Title		PTN150A and PTN36043	
Size	Document Number	PTN150A Application Board	
C	Rev	A1	
Date:	Friday, July 20, 2018	Sheet	1 of 1

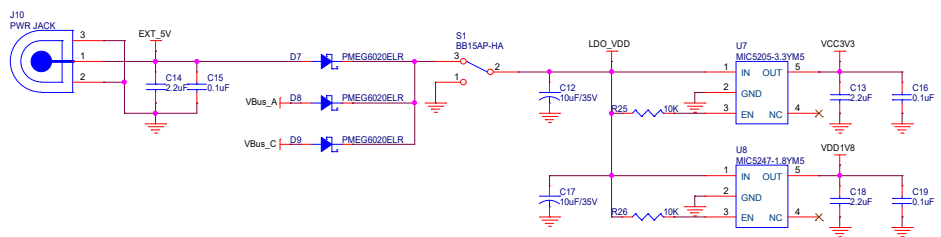
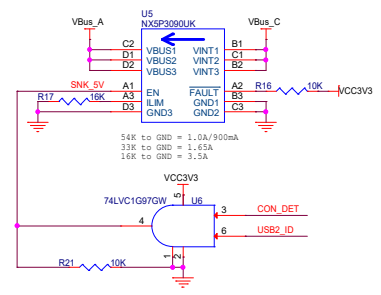
** Update R15 to 1M. This is to raise the VBus detection threshold from 3.3V to around 4V range. This is also to compliant with latest Type C spec 1.3
